FORMANT.
STRAIGHTFORWARD ACOUSTIC DESIGN

PRINCESS ROYAL THEATRE PORT TALBOT

STAGE 3 ACOUSTIC DESIGN REPORT

Project no. P1253
Report ref. 26CC03-FOR-10-XX-T-OJ-0003
Revision: P01
Date 29-08-2024

Figure 9: Topakustik Microperforated 3/3/0.5

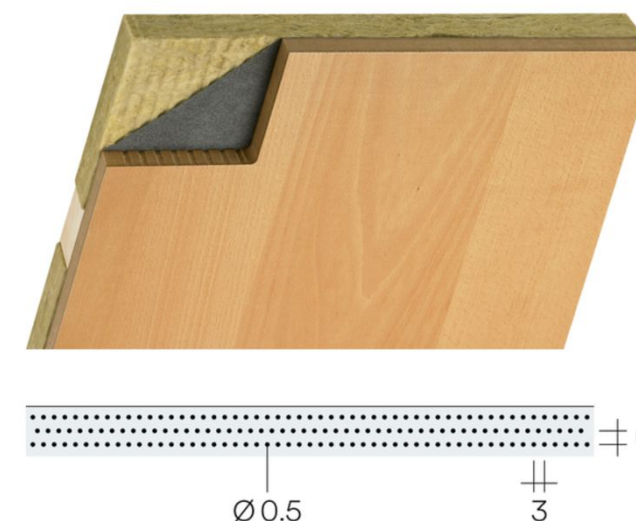
The ceiling underneath the balcony should be changed to a surface which provides slightly less absorption than the existing mineral fibre tile. This could be achieved with a mix of some perforated and some non-perforated timber panels, or with a 'mid-range' perforated panel throughout.

During Stage 3 the architect has suggested a Topakustik micro-perforated timber panel. We have reviewed the acoustic data for the different micro-perforation options and the most suitable is the 3/3/0.5 pattern, which achieves Class C absorption. During Stage 4 we will include this option in the updated room acoustic model and check suitability.

Figure 10: Suggested acoustic tuning absorption zones on ground floor (L) and balcony (R) rear walls.

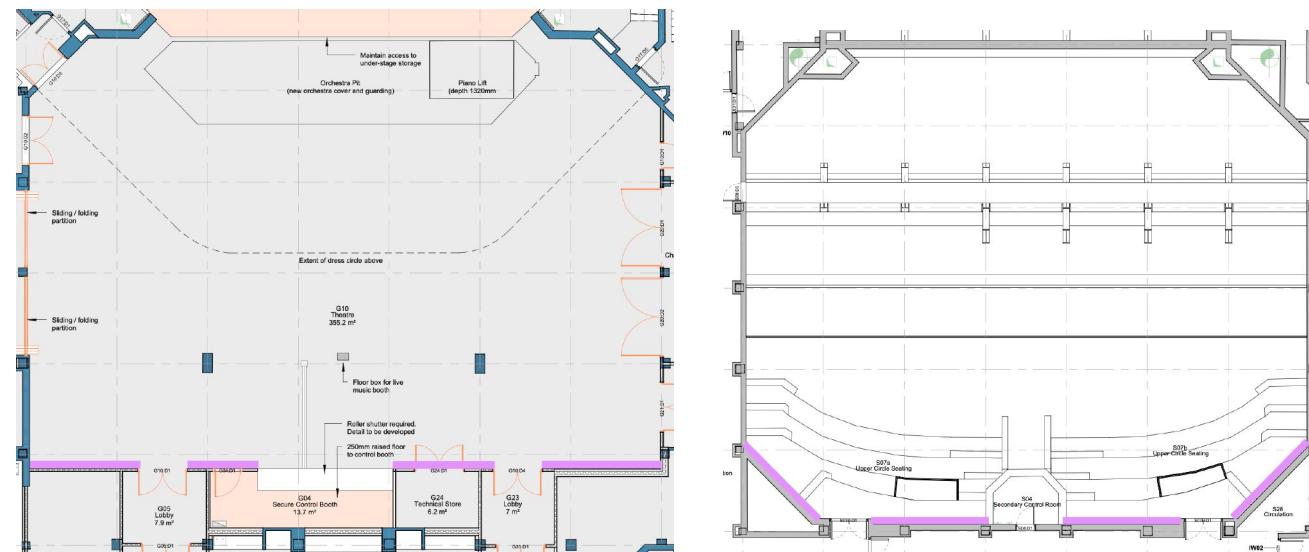
As described above, the inherent uncertainty in the acoustic modelling of existing materials means we cannot predict the exact room acoustic conditions, therefore **we recommend an area of ‘tuning absorption’ be allowed for on the architectural plans and in the costplan.**

The suggested location for the absorption zones is on the rear walls of the auditorium and ground and balcony level, as marked up on the floor plans below:

We recommend allowance be made for an acoustic panel absorber with a worst-case depth of 200 mm formed by timber battens, 50-100 mm mineral wool in-fill and a finish comprising either solid or perforated plywood.

Figure 11: The proposed re-used timber acoustic feature wall will provide effective absorption provided that it has gaps between the slats and mineral wool absorption behind.

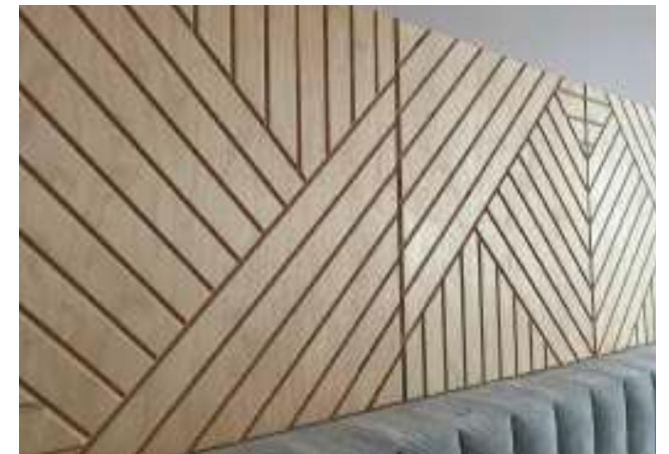
Additional absorption will be provided by the soft furnishings, carpet flooring and by the proposal to re-use some of the maple stage flooring to create feature wall panels. In order for the feature wall panels to provide effective acoustic absorption, they should be mounted on a frame of at least 50 mm depth, with 25 mineral wool installed behind the panels and gaps left between the panels to achieve at least 15% open area.

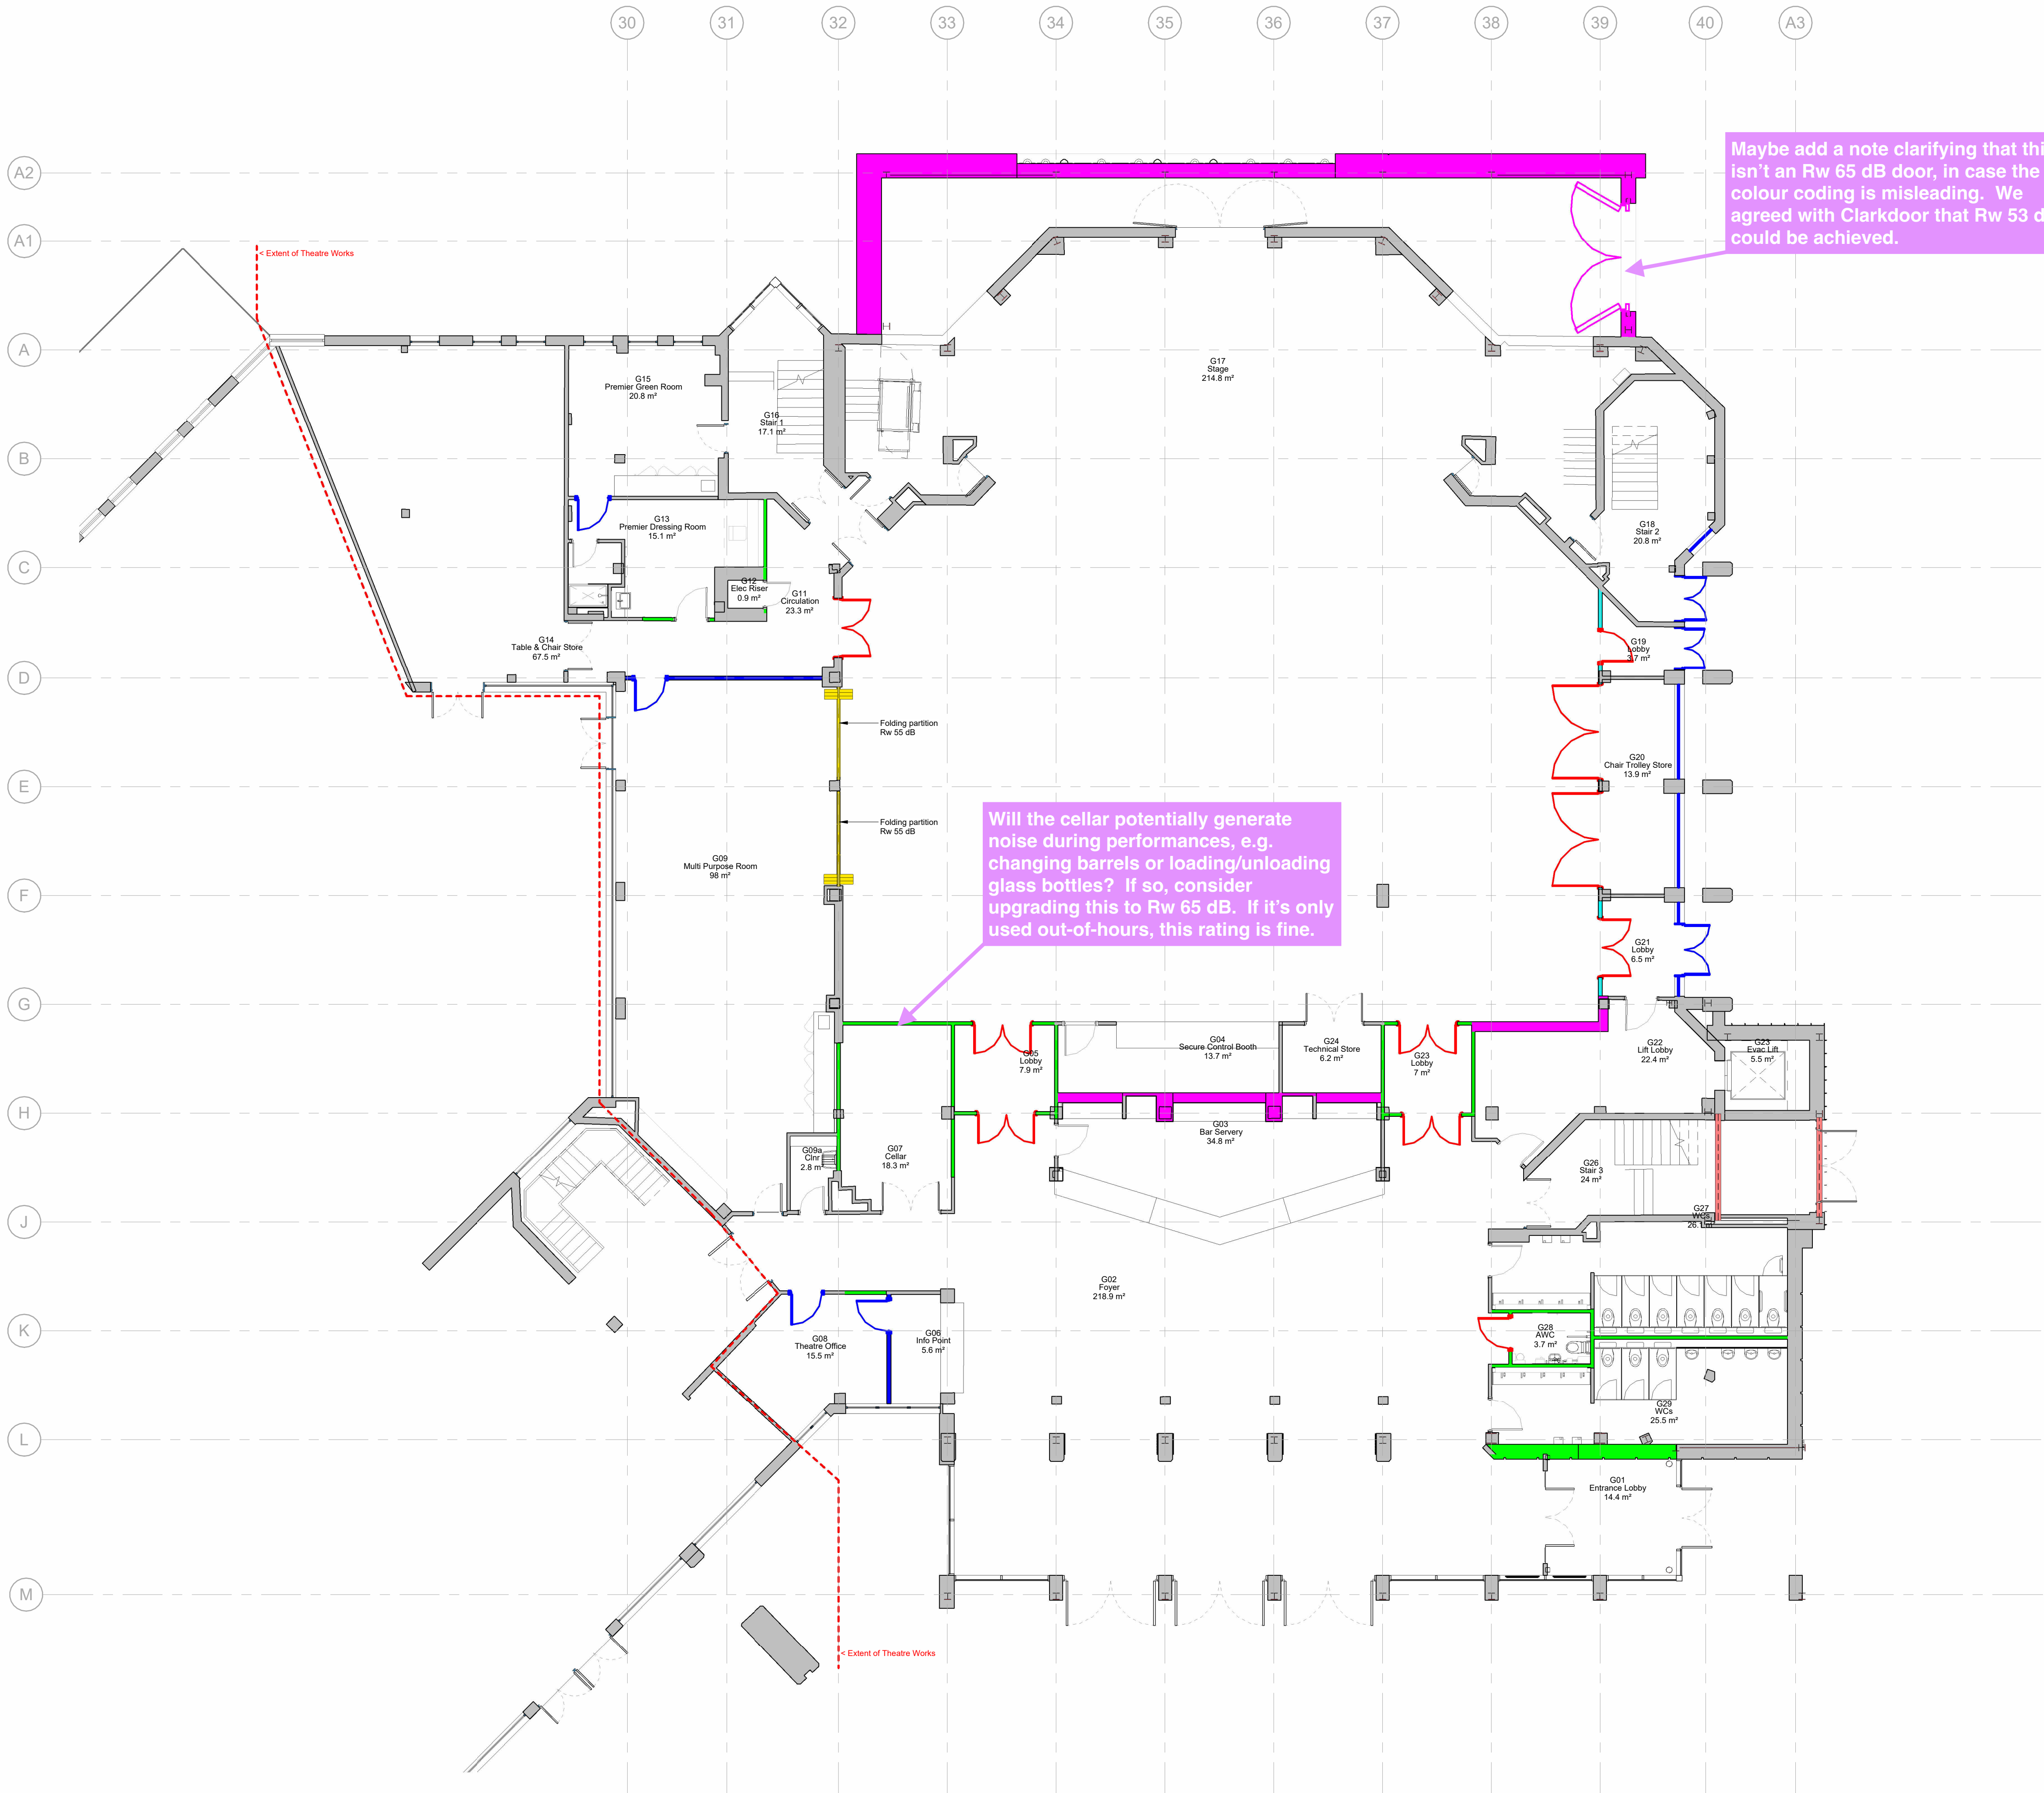
Existing Walls:
Acoustic ratings indicated are not verified. Acoustician to review construction record data and/or undertake onsite testing to verify walls will reach the proposed ratings.

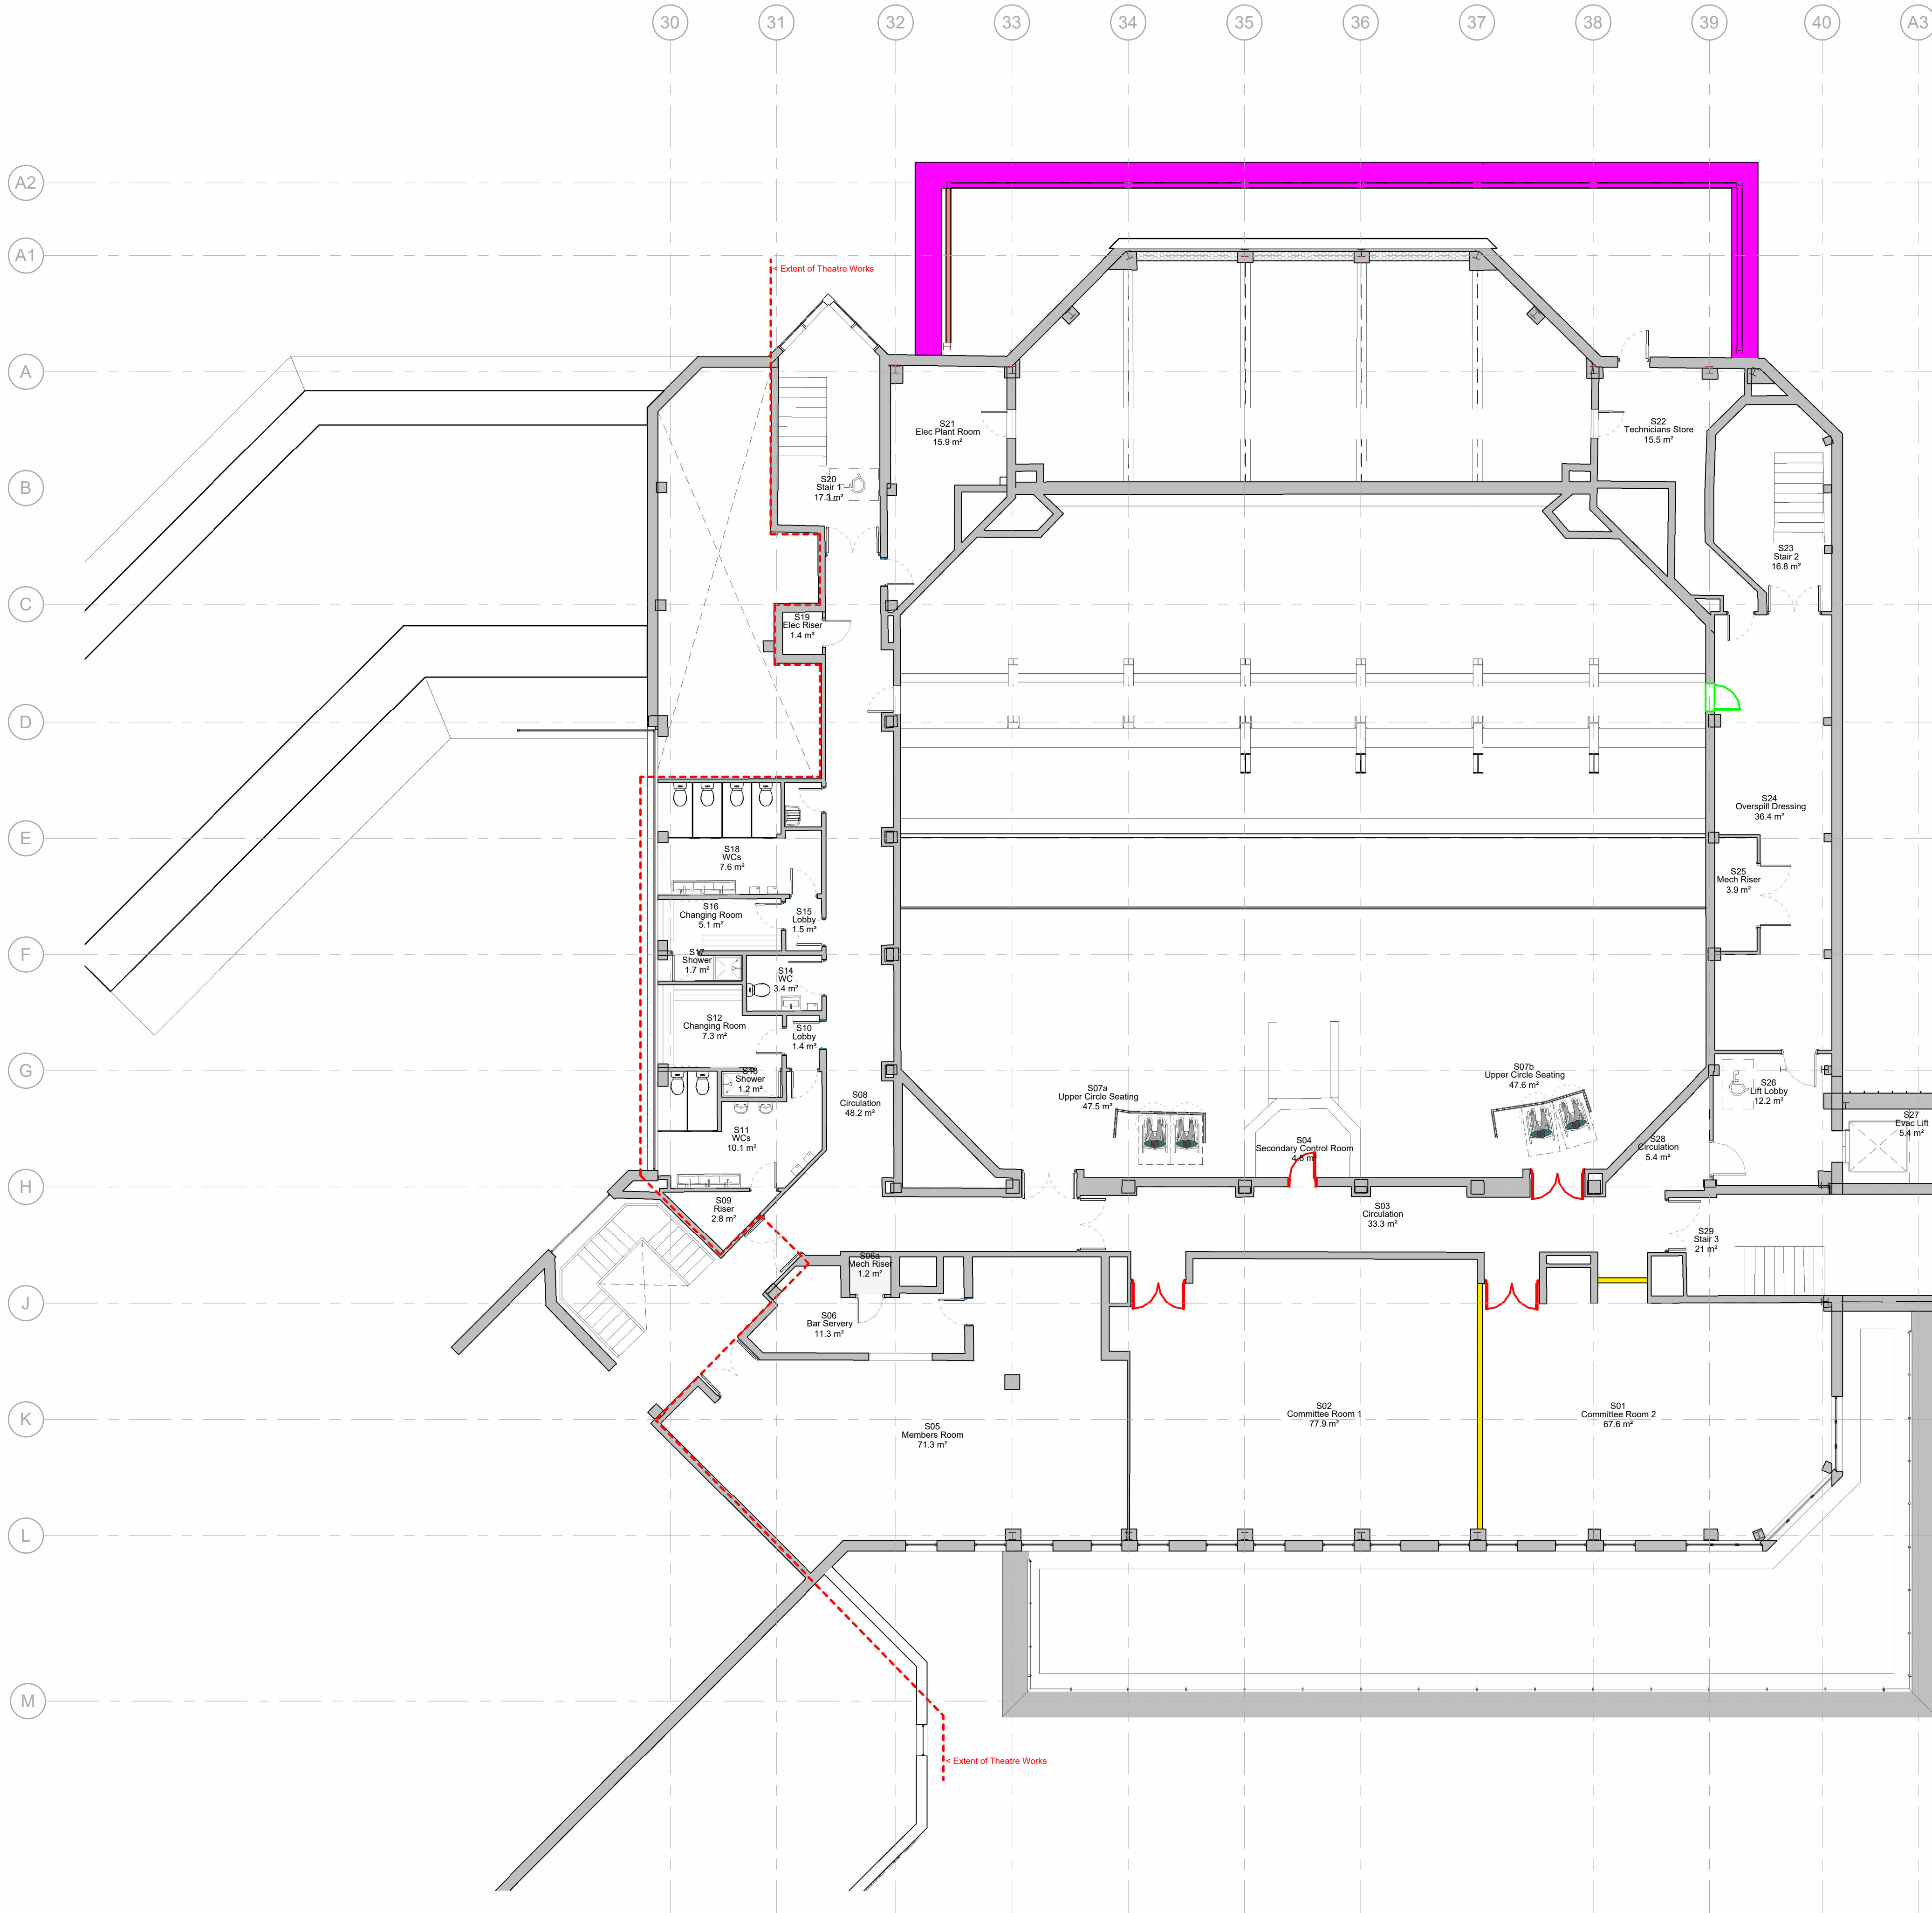
Existing Internal Doorsets:
Condition survey report to be conducted to all required internal doorsets in order to establish the doorsets current fire and acoustic performance ratings.

Existing Walls:
Acoustic ratings indicated are not verified. Acoustician to review construction record data and/or undertake onsite testing to verify walls will reach the proposed ratings.
